12/03/2019

ADDENDUM 02

Project:
Kinesiology Labs and Aquatic Center
Liberal Arts Campus
Long Beach, CA 90806

WW Project No. 16042.01
DSA Application No. 03-119628
File No. 19-C3

SHEET DESCRIPTION:
PLUMBING UNDERGROUND PLAN W-P200.2

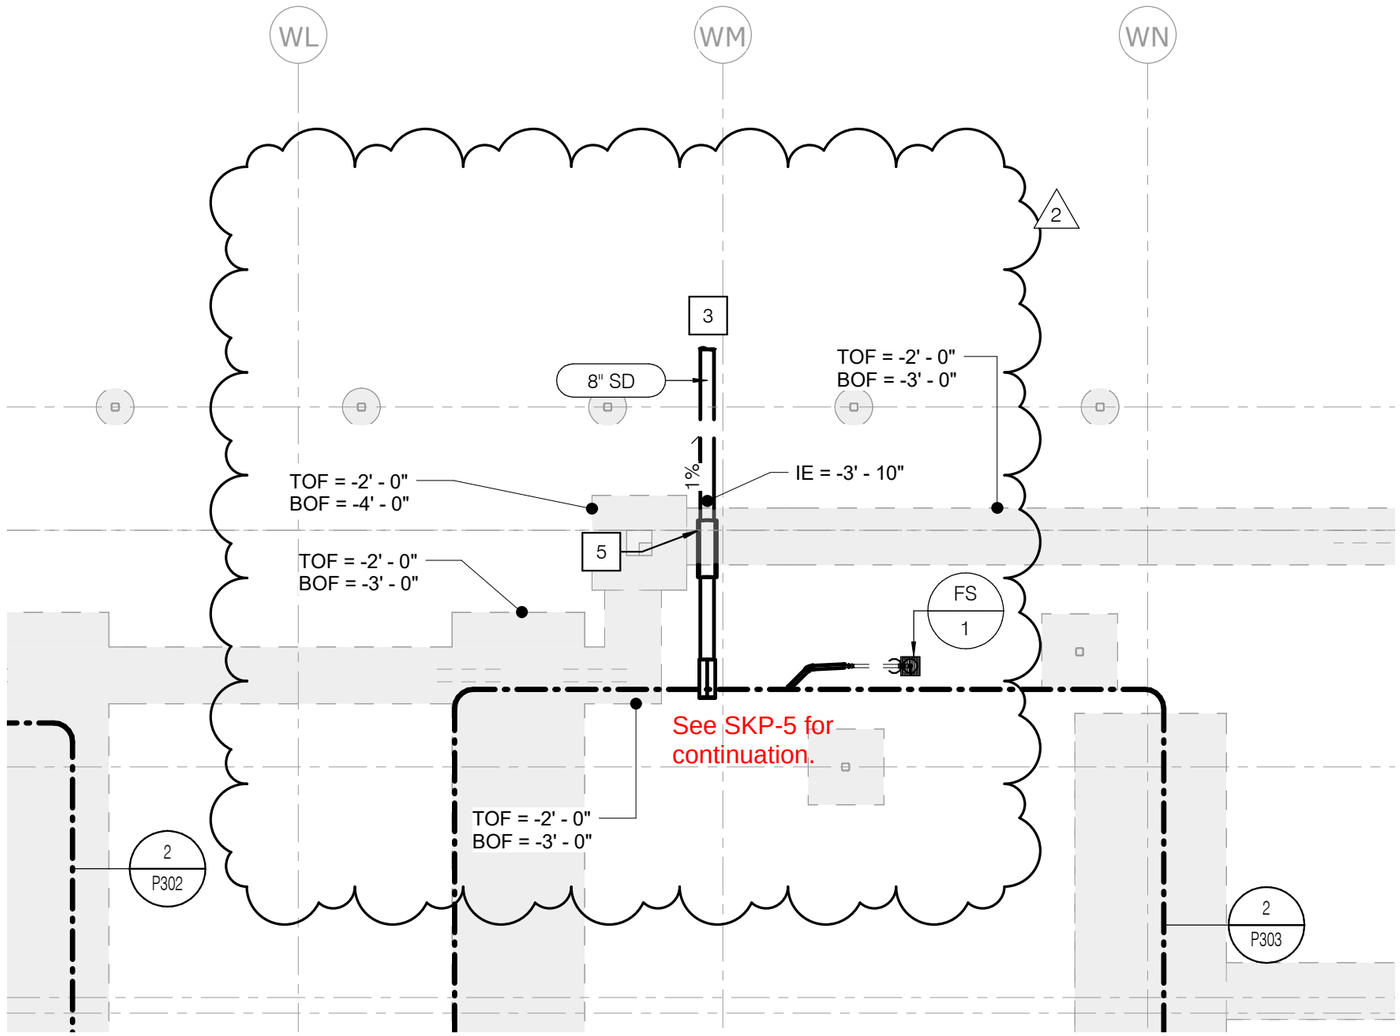
THIS SKETCH MODIFIED DRAWING W-P200.2

2 BLDG. "W1" ROOMS W118, W119, & W121 (WASTE & VENT) - BELOW GRADE

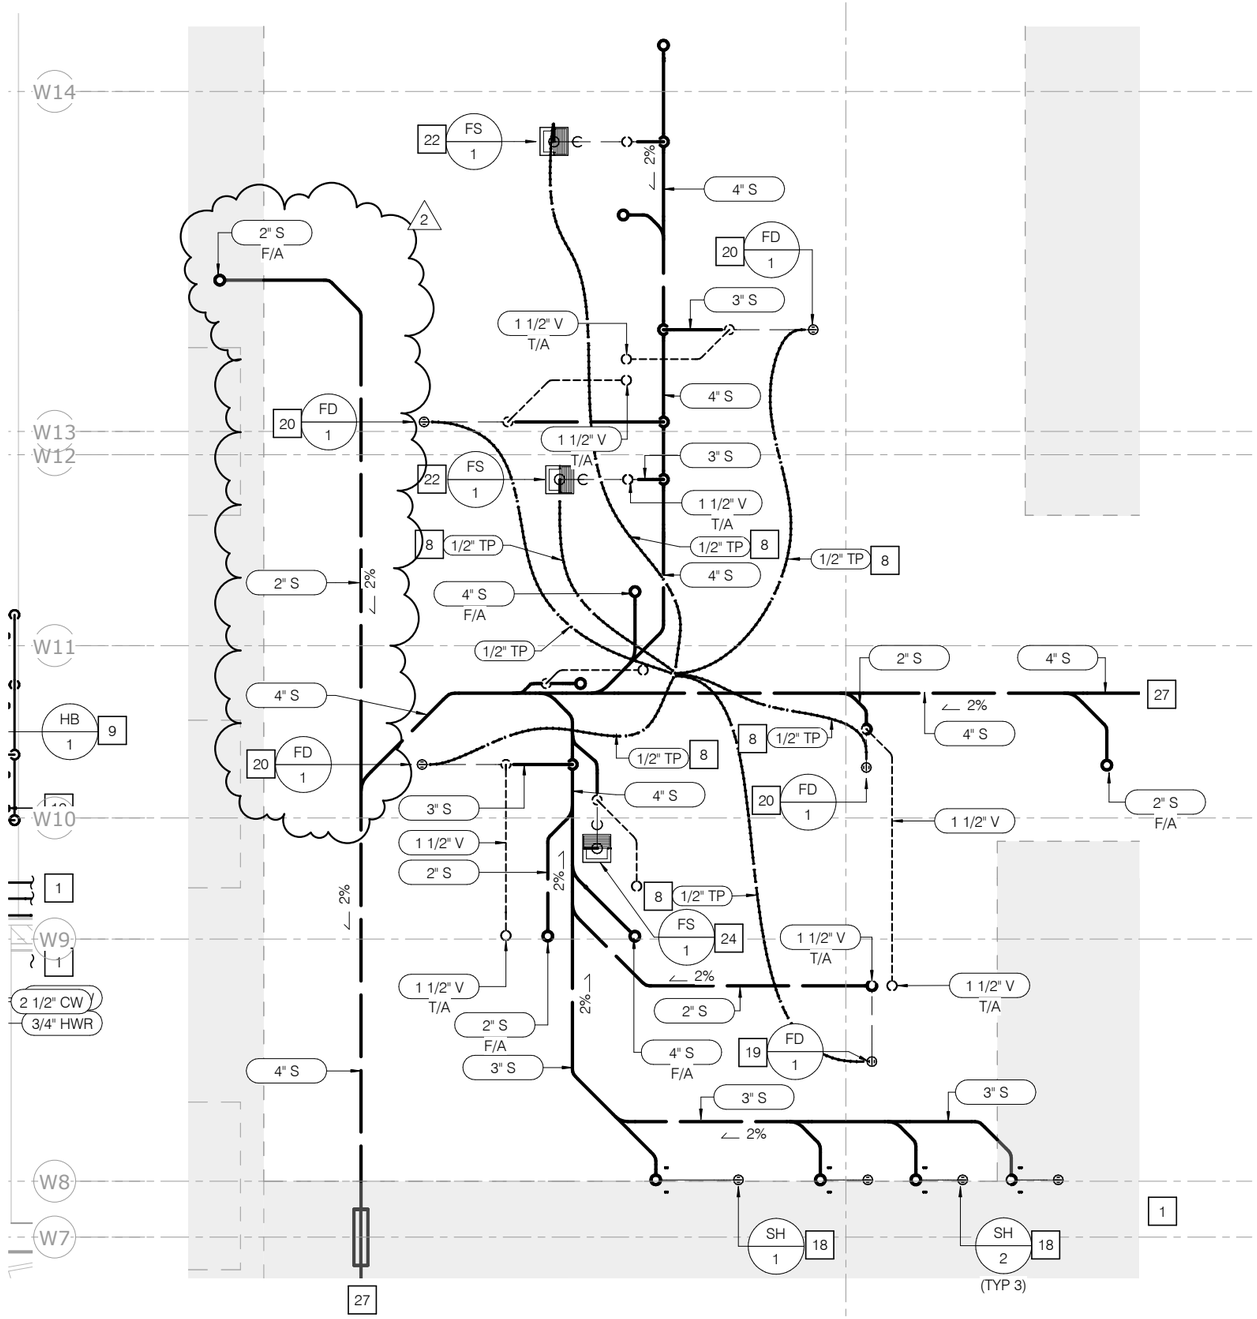
THIS SKETCH MODIFIED DRAWING P302

2 BLDG. "W" ROOMS W126 & W131 (WASTE & VENT) - BELOW GRADE

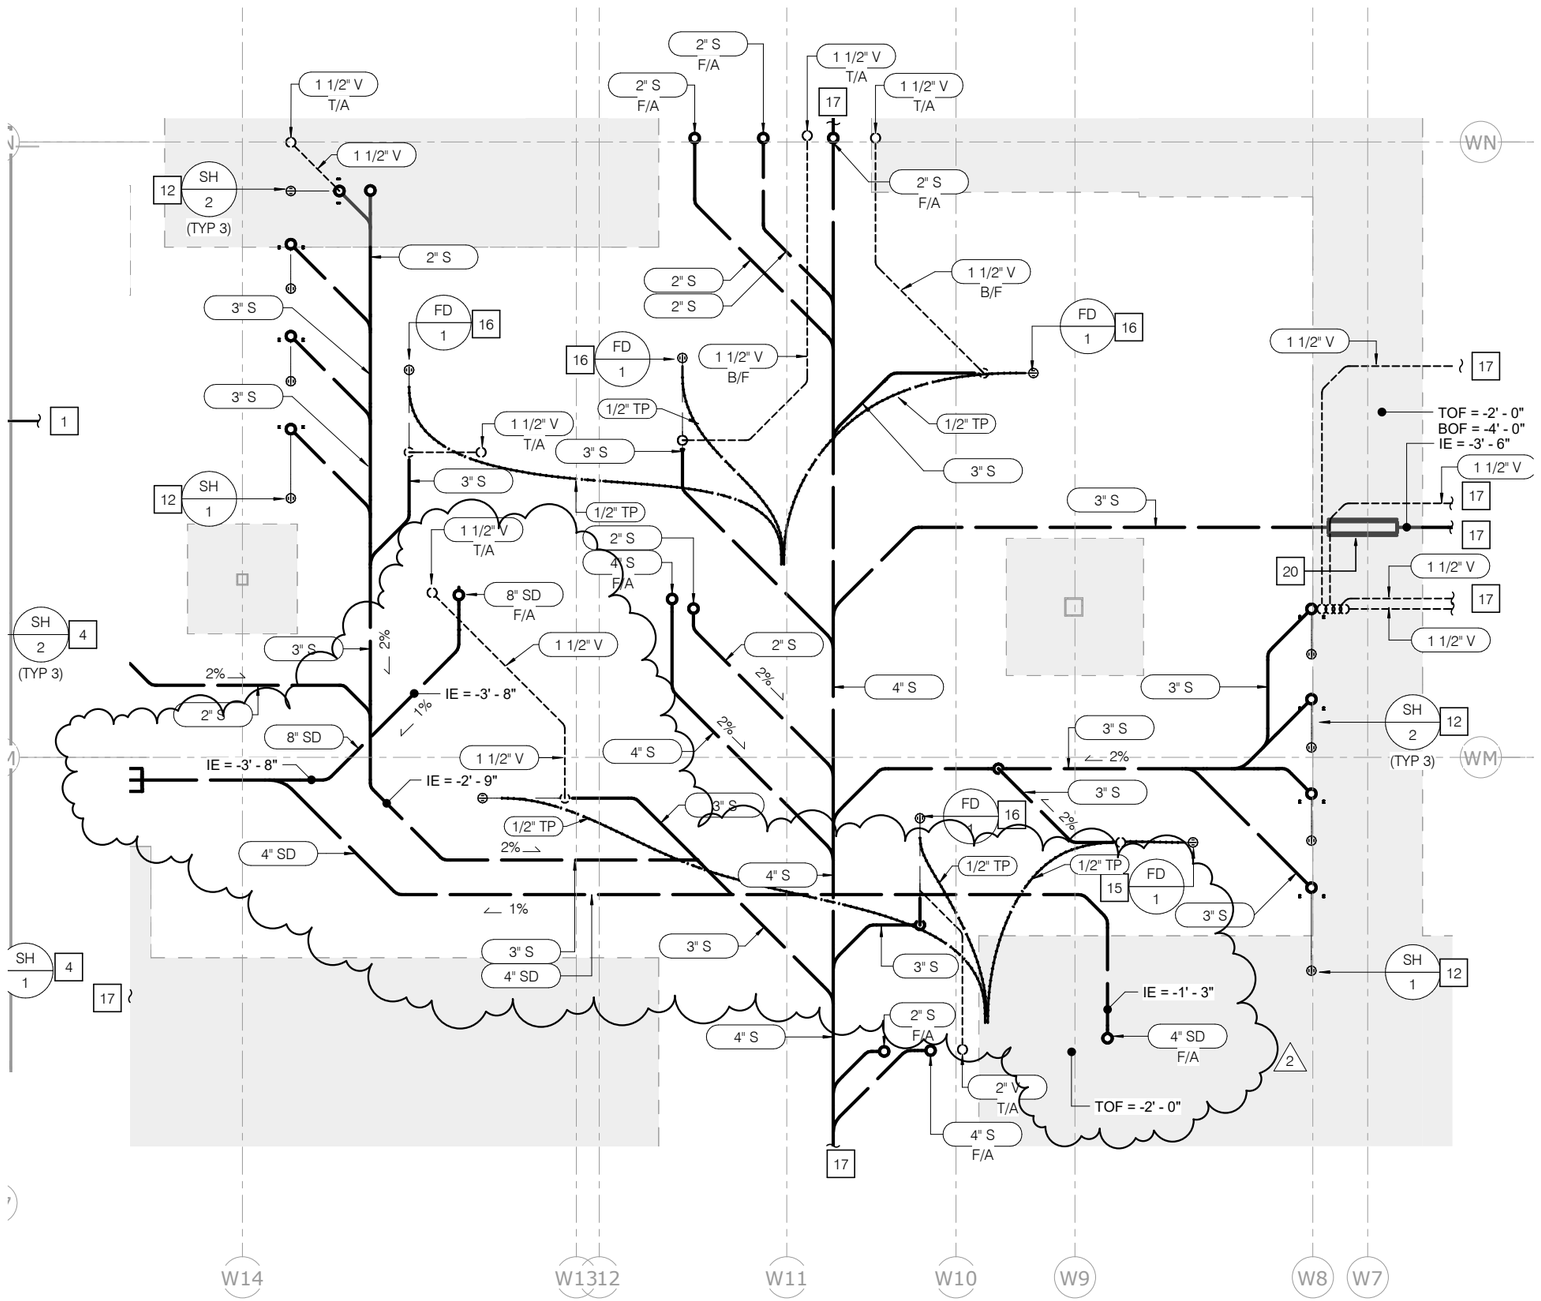
THIS SKETCH MODIFIED DRAWING P303

1 BLDG. "W1" ROOMS W103, W104, W105, W107 & W108 (WASTE & VENT)

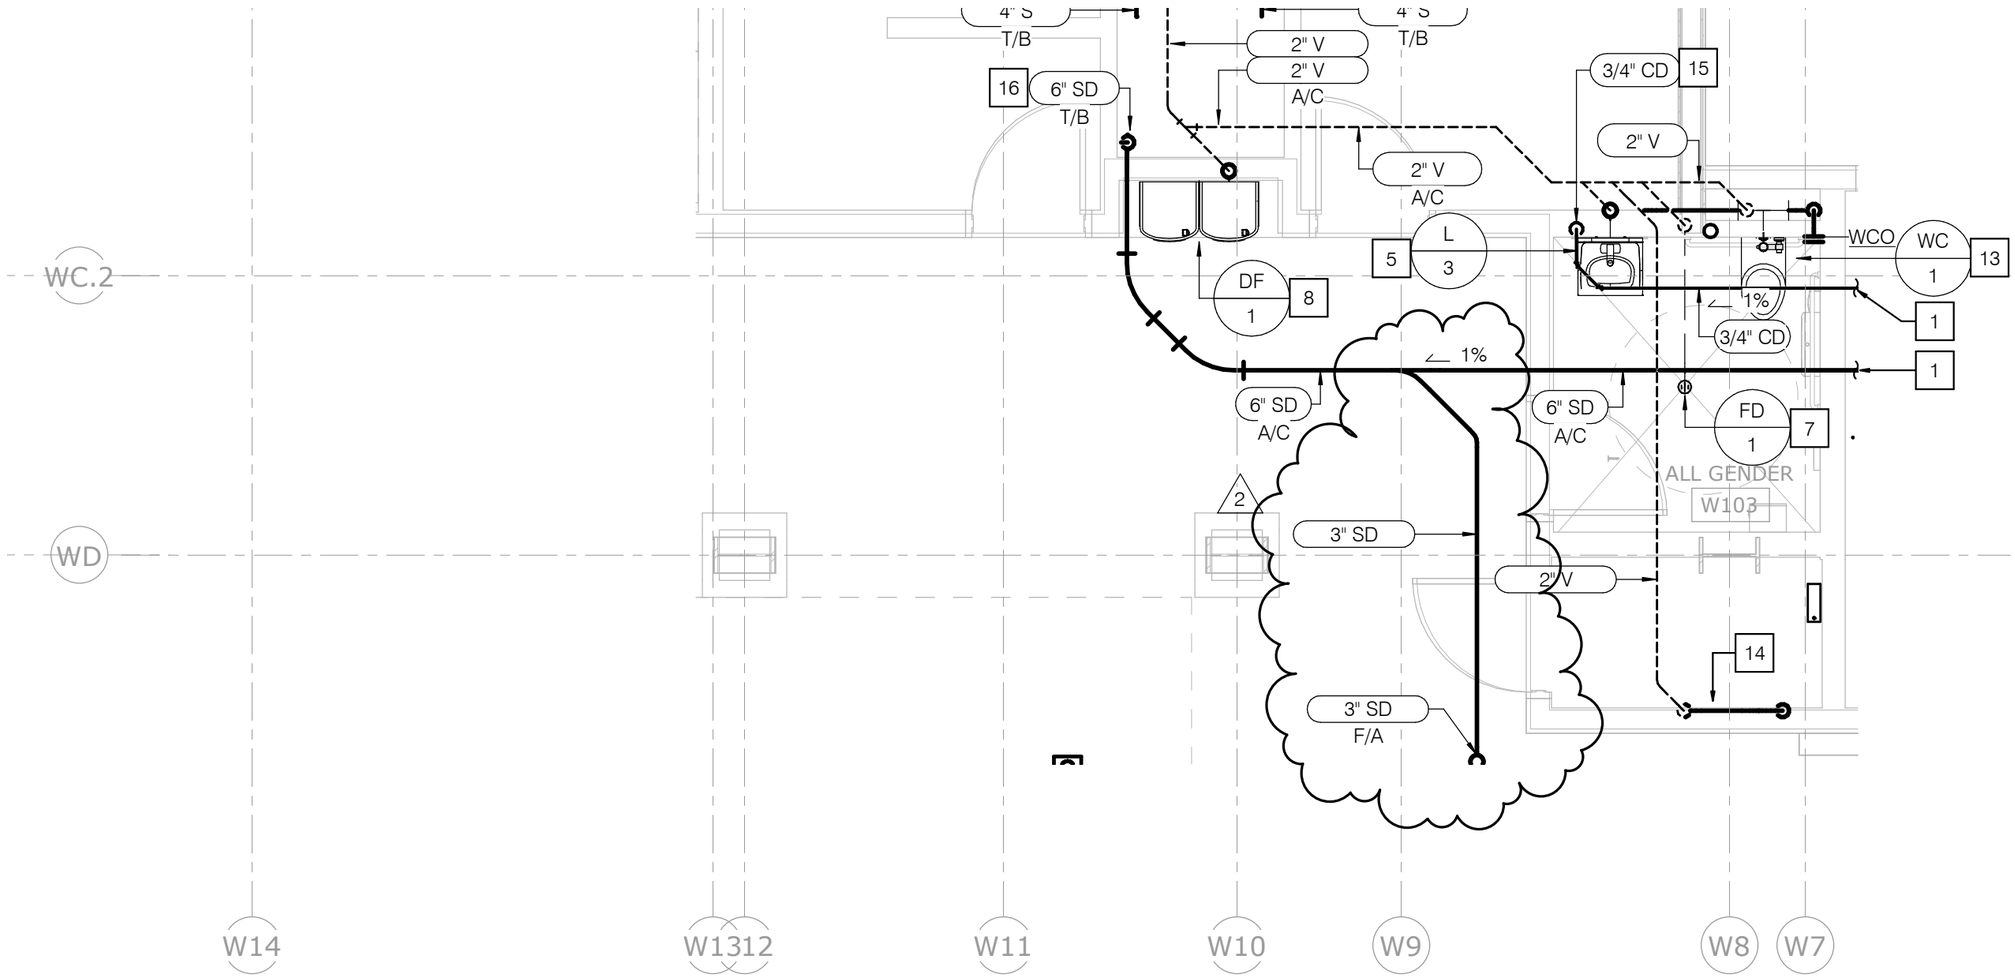
THIS SKETCH MODIFIED DRAWING W-P301.1
